IMPORTANT SAFETY RECALL NOTICE - May 29, 2009

Model 22A Pistols

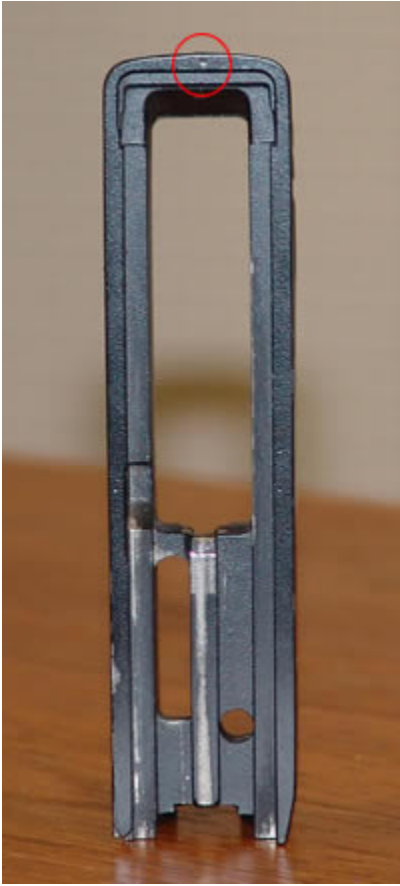
Smith & Wesson has identified a condition that may exist in certain model 22-A pistols. Based on our ongoing product review, we have determined that the slides of certain pistols manufactured from August 1, 2008 to February 19, 2009, may not meet the design specification. This can create a situation where insufficient headspace exists creating a risk of unintended discharge.

When your pistol is returned, you should note a punch dot which appears on the rear underside of the slide. This punch dot can be seen by locking the slide to the rear and looking at the underside of the slide as seen in the photograph below.

This punch dot is verification that your slide meets specification and the pistol is safe to use. If your pistol already has this punch dot, you do not need to return the firearm.
